**Response to Comments on my
Report on the Fire at
9 – 15 Moss Hall Grove, North Finchley, N12 8PE
on the 8th June 2023
by**

Ref: AC-5

6th September 2024

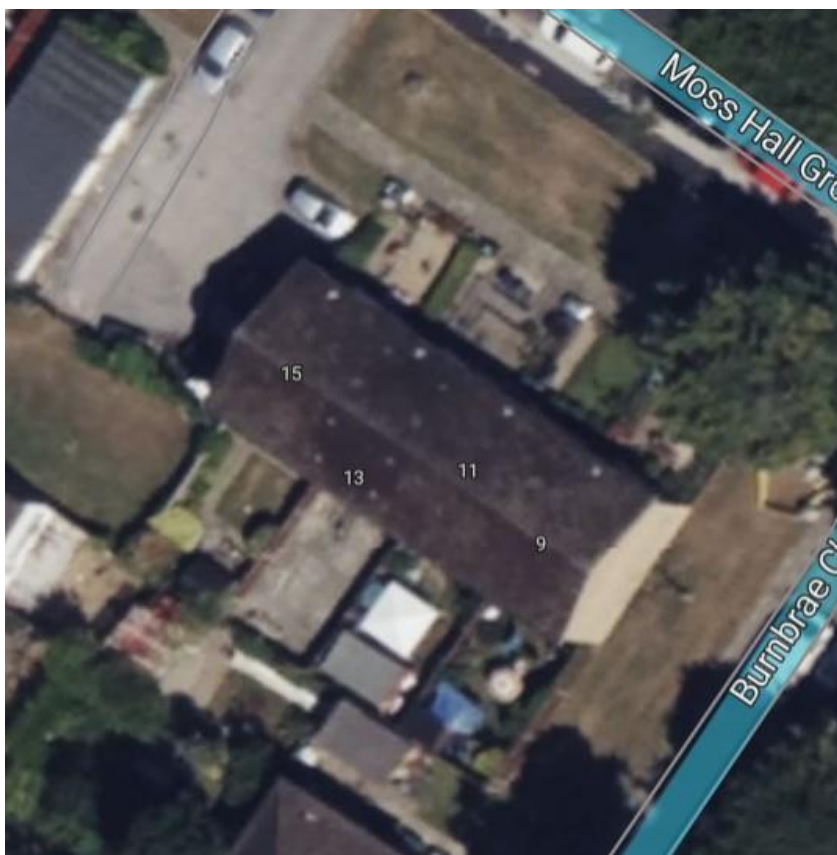
Para 4.4: Subsequent to writing my report, I obtained a photograph that provided a clearer view of the destruction of the roof above the party walls – see photographs 3 & 4 of this present report. No remains of fire-stopping are visible. This new photograph does not change my view on this aspect which, in any case, does not seem to be in dispute. Had the initial fire affected only house 11, once its roof void became involved the fire would almost certainly have quickly spread into the roofs of houses 9 and 13 via gaps above the heads of the party walls.

3. This photograph, from social media, was taken during the final stages of fire-fighting. It gives a better view of the head of the party walls than photograph 6 in my report of 16/7/24. Charred pieces of tiling battens remain in place where they pass over the party walls. There should have been fire-stopping between the battens where they pass over the party wall but none is visible, suggesting that it was never present.

4. A closer view of the head of the party wall between houses 11 and 9.
